**RE: INTERIM ACTION WORKPLAN
FORMER SATRALLOY SITE (JEFFERSON COUNTY, OHIO)**

On behalf of Cyprus Amax Minerals Company, this letter proposes a change to the Interim Action Workplan approved by the Ohio Environmental Protection Agency. The interim action contractor suggested that the location of the baghouse dust staging area be moved from the concrete floor of the North Mill Building to the concrete pad adjacent to the North Mill Building. This change would allow the demolition to be performed without two mobilizations, and would decrease the possibility of damage to the staging area during demolition activities. There would be no change to the approved design of the staging area, and appropriate stormwater controls would protect the staging area from stormwater flowing into the staging area.

FORMER SATRALLOY SITE
STORMWATER POLLUTION
PREVENTION PLAN

STORMWATER FLOWS,
CONTROLS, AND
SAMPLE LOCATIONS
PLANT AREA

IAS-520

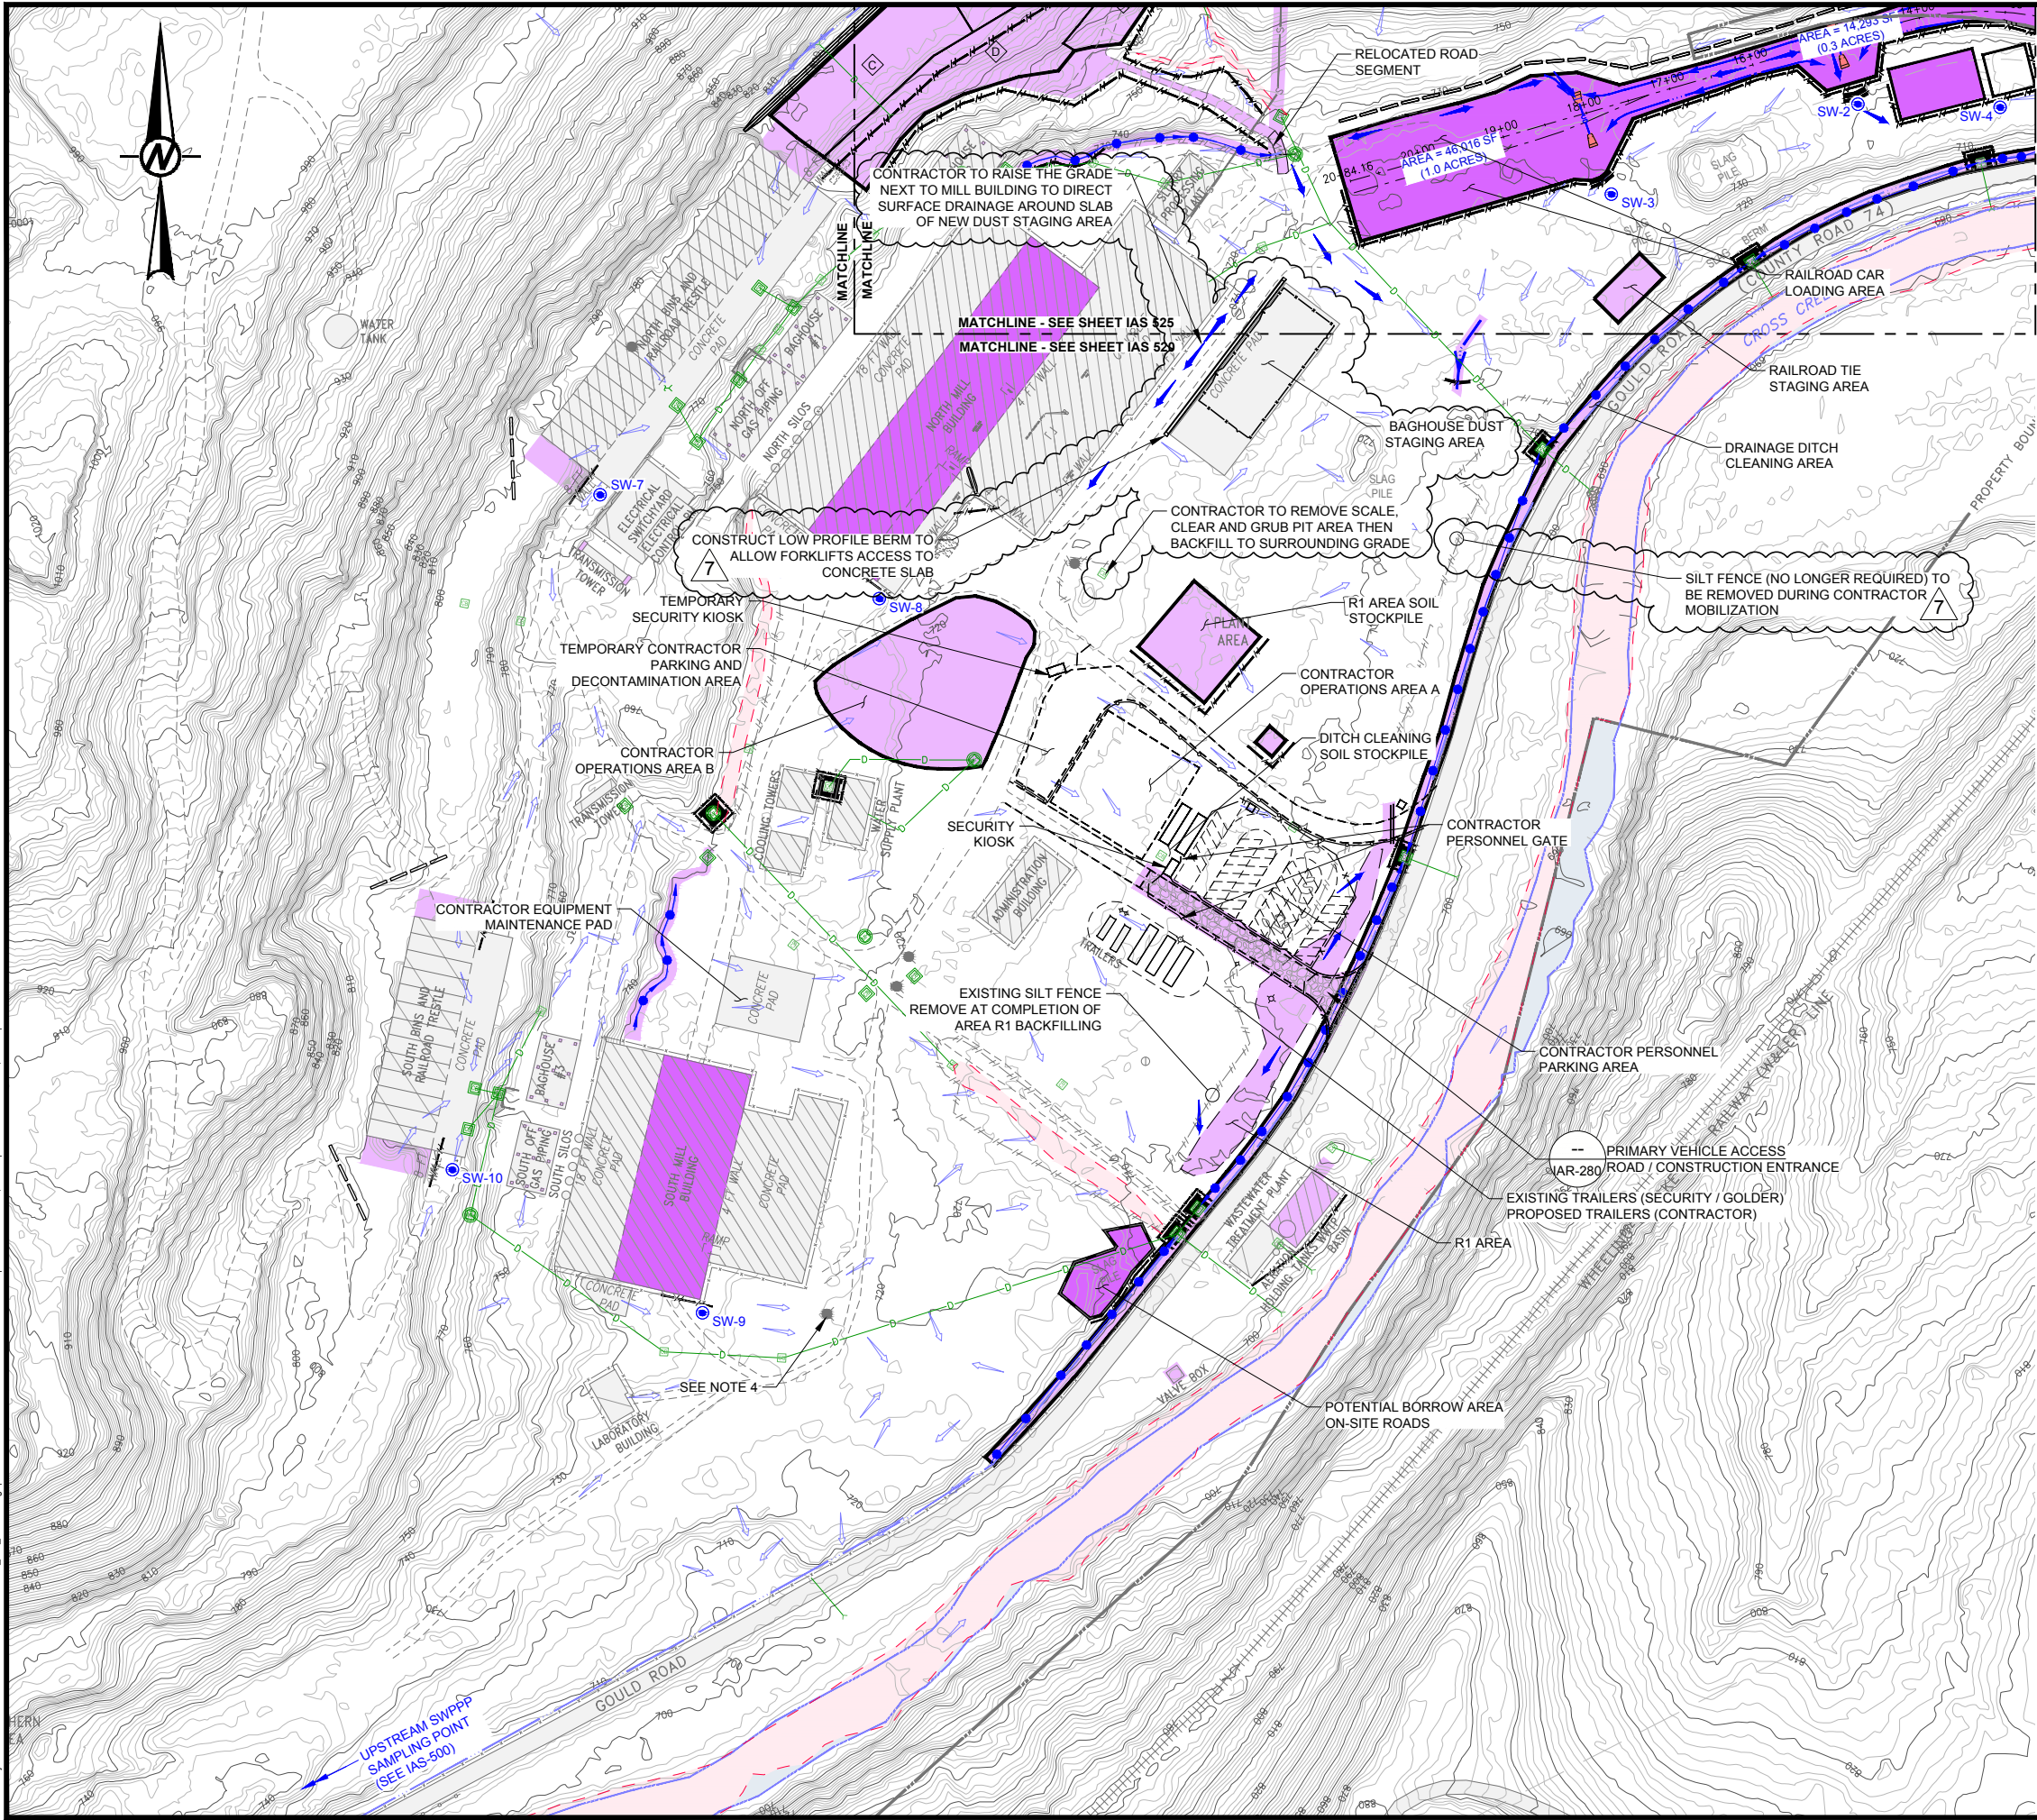
The proposed change is shown on the attached revised drawing IAR-520.
